Date: February 11, 2021
To: Capitol Area Architectural and Planning Board (CAAPB)
From: Peter Musty, Principal Planner (and Zoning Administrator), CAAPB
RE: Agenda Item #5: Zoning Application – St. Paul City School

2.1. Project Summary: St. Paul City School

Subject: **Public Notice of Zoning Variance Application**
Corner Setback for New School Building
@ Northeast Corner of Marion and University
215 University Avenue W., Saint Paul, MN 55103

School Entry Plaza at University and Marion.

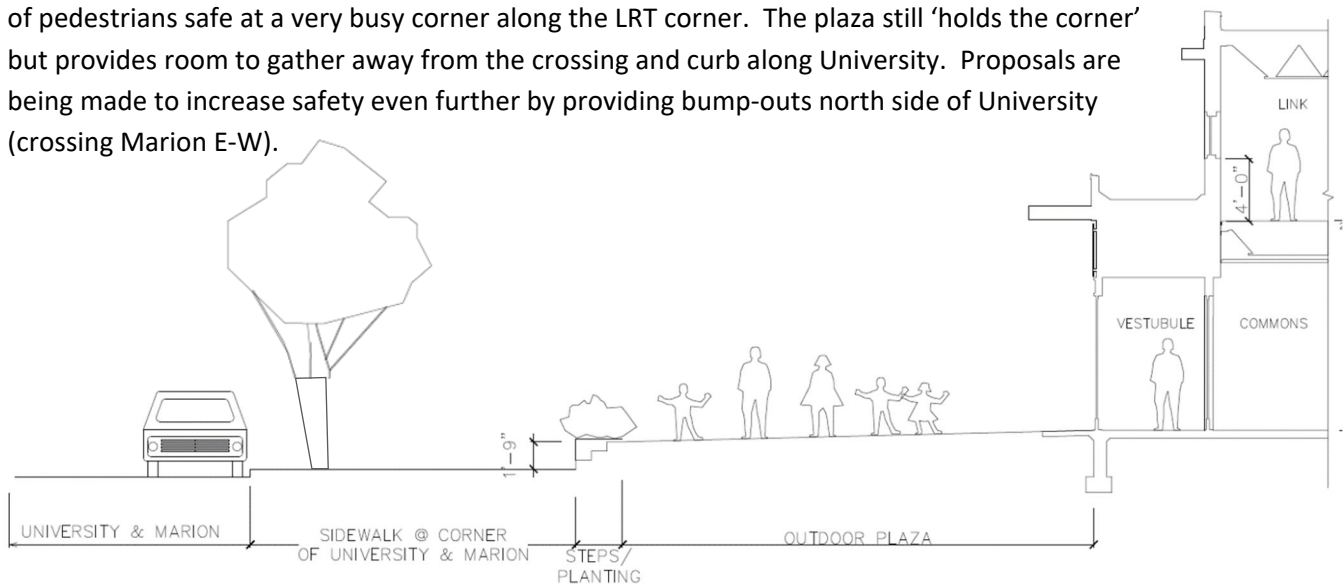
The school will welcome many kids, families and community members into the building at University and Marion . Above is an illustration of the building looking northeastward from University and Marion Avenues. To the right is the same vantage point, cropped from Google Earth. The diagram (below) shows how the building relates to the corner. The plaza setback does require a variance to be granted by the Board, which will be considered and voted upon at the meeting. CAAPB staff supports the Variance, based on the need to keep groupings of pedestrians safe at a very busy corner along the LRT corner. The plaza still ‘holds the corner’ but provides room to gather away from the crossing and curb along University. Proposals are being made to increase safety even further by providing bump-outs north side of University (crossing Marion E-W).

The plaza setback does require a variance to be granted by the Board, which will be considered and voted upon at the meeting. CAAPB staff supports the Variance, based on the need to keep groupings of pedestrians safe at a very busy corner along the LRT corner. The plaza still ‘holds the corner’ but provides room to gather away from the crossing and curb along University. Proposals are being made to increase safety even further by providing bump-outs north side of University (crossing Marion E-W).

The 3-story ‘Classroom Wing’ on Marion:

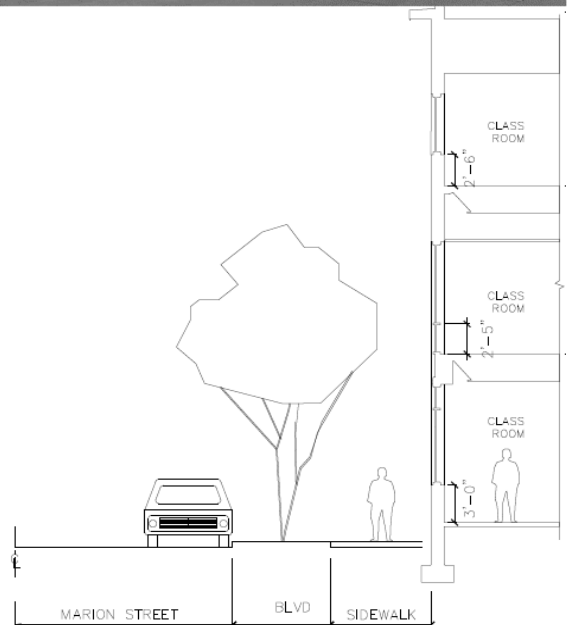
The school addresses Marion Avenue with a formal three story façade facing west, with one large window per classroom in the ‘classroom wing’ of the building. As the building turns to face more residential (two story homes) along Sherburne, the detailing and scale breaks down from three to two stories) and becomes more informal architecturally, while still holding the street as the grade rises to the east. Above is the future illustration of the building looking southeastward from University and Marion and Sherburne intersection. To the right is the same vantage point, cropped from Google Earth. The diagram (bottom right) shows how the building relates to the street along Marion.

BUILDING PLACEMENT
 Section 2040.2225
 Section 2400.2400 /Subp.2
 Section 2400.2400 /Subp.7
 Section 2400.2620 /Subp.8

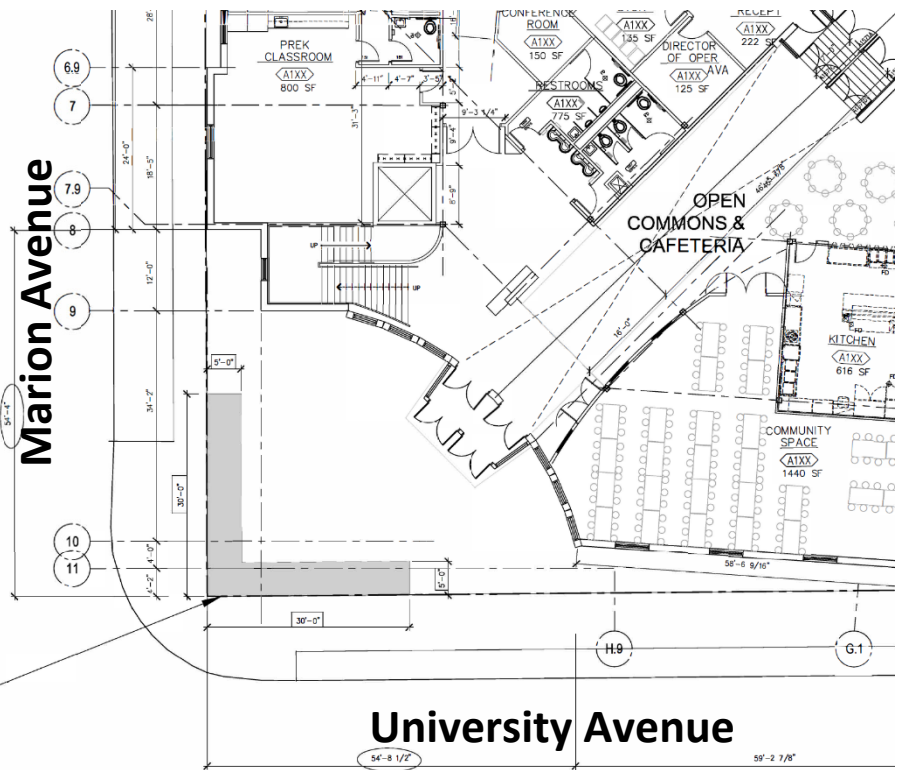
As shown in the attached drawing, the applicant proposes setting back the façade of the building (at the corner) further than is allowed by the rules, and therefore a variance is necessary.

Subpart 7 - flexible frontage :
 building at corner locations must be located within 5'-0"
 of the front lot line on either street for a distance of
 30'-0"
